**RAI Volume 2, Chapter 2.1.1.3, First Set, Number 9: Second Supplemental Question:**

**1. SECOND SUPPLEMENTAL RESPONSE**

Figure 1. April 15, 2004, Military Aircraft Trace Plots on the Nevada Test and Training Range and Military Operations Areas provided by U.S. Air Force

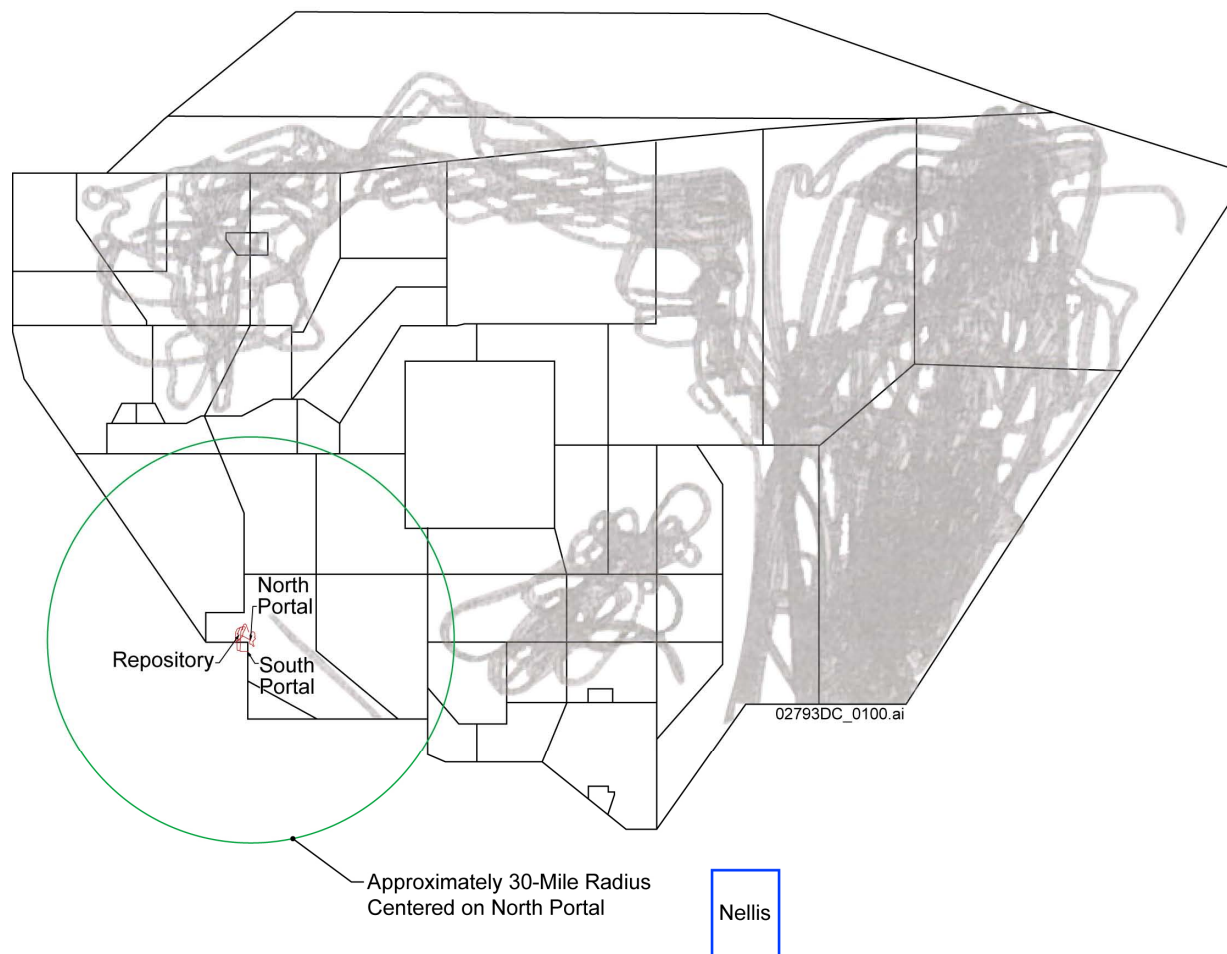
Page 2, last paragraph: In its supplemental question which deals with distance from mishap initiation to crash, and hence with the cumulative distribution function  $F(r)$  in Equation 9 of reference BSC 2007c, the function  $F(r)$ , as shown in Figure 5 of the reference is the distance of pilot ejection to crash. NRC does not understand how this can be conservative for the important subset of mishaps due to engine failures. About 25% of all military aircraft mishaps are engine failures. In such cases, pilots will not, in fact, eject immediately upon loss of engine. Instead, they are trained to attempt an engine restart. Their direction of travel should thus be assumed to be random from the initial engine failure point, and the travel distance should be the maximum glide distance. Such glide distances for typical F-16 situations are determined by the aircraft altitude, plus about 3000 ft for zoom, and the glide ratio of 8.4. Thus for aircraft even as low as 2000 ft,  $2000 + 3000 \times 8.4$  is 8.4 miles. Aircraft operating at more typical altitude of 3 miles would travel about 25 miles. Thus, it appears that most of the engine failure crashes would have traveled more than the 5 mile restriction radius, far enough to reach from outside the restricted airspace to the target area, and hence should be mostly included in crashes estimated to occur within the target area without considering the restriction. Conversely, as can be seen for the  $F(r)$  plotted in Figure 5, distances from ejection to crash are almost always quite short. Thus, using the function from Figure 5 on distances from ejection to crash does not appear to be conservative for engine failure events. What appears to be needed for this separate piece of engine failures is an  $F(r)$  curve for distance from mishap initiation to crash.

The absence of crashes within the 30-mile radius is not random. It results from a consistent pattern of flights as shown in Figure 1. Figures 1 and 2 provide support for the insight that the uniform crash frequency density within the 30-mile radius would be expected to be lower because the preponderance of flight paths and crashes are far from the repository (significantly further than the analogous flight path considerations in NUREG-0800). Notwithstanding that and even though the DOE currently allows only military transitory type flights through the Nevada Test Site, the uniform crash frequency density of  $7.5 \times 10^{-5}$  crashes/yr/mi<sup>2</sup> was conservatively applied to the area within 30 miles of the repository without reduction. The uniform crash

Figures 1 and 2 show that the flight activity occurred in the Nevada Test and Training Range and military operations areas, and the crash sites remained in the Nevada Test and Training Range and military operations areas. Because the crash frequency density is determined from the location of the crash sites, not from the point of mishap initiation, it could be assumed that with no flight activity occurring within the flight-restricted area below 14,000 ft mean sea level, any crash-initiating event that occurred outside the flight-restricted area, based on the crash frequency density, would also remain outside this area. However, a crash frequency from military training activity outside of the flight-restricted area is determined from this crash frequency density. The function  $F(r)$  is used to extrapolate the uniform crash frequency density from outside the flight-restricted airspace to the vicinity of the surface facilities inside the flight-restricted radius. Given that the use of a uniform crash frequency density eliminates the need to have knowledge of the flight path, the distance the aircraft travels, or actions that a pilot may take following a mishap because it is based on crash impact points, the  $F(r)$  is developed from information of aircraft behavior after the pilot leaves the plane.

The uniform crash frequency density used in the analysis is derived from military flights that occur in a region outside of a 30-mile radius of the repository. The lack of crashes within the 30-mile radius is not random but results from a consistent pattern of flights, as shown in Figure 1, which is from one day in the date range of flight data used in the analysis (BSC 2007). Figure 2 plots the 18 crashes that have occurred on the Nevada Test and Training Range and military operations areas (BSC 2007, Table 8). Figures 1 and 2 provide support for the insight that the crash frequency density within the 30-mile radius would be expected to be lower because the preponderance of flight paths and crash sites are far from the repository.
